From: Benzie, Richard (DEQ)
To: [Cook, Pat \(DEQ\)](#)
Subject: FW: Flint schematic in OEL
Date: Friday, October 02, 2015 4:00:00 PM
Attachments: [image002.png](#)

From: Crooks, Jennifer [mailto:crooks.jennifer@epa.gov]
Sent: Friday, October 02, 2015 12:46 PM
To: Busch, Stephen (DEQ); Prysby, Mike (DEQ); Rosenthal, Adam (DEQ); Benzie, Richard (DEQ)
Cc: Poy, Thomas
Subject: Flint schematic in OEL

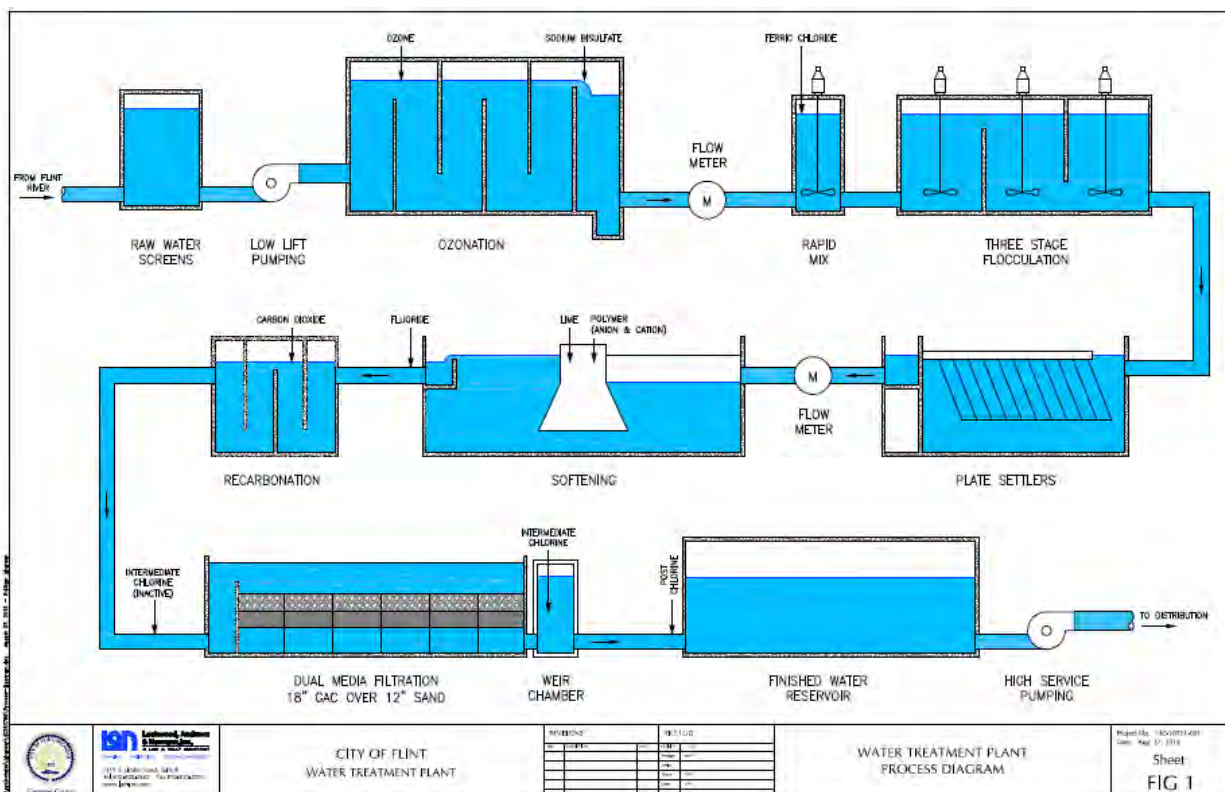
Have we routinely allowed filter plants to have only 12-inches of sand in there dual-media filters?
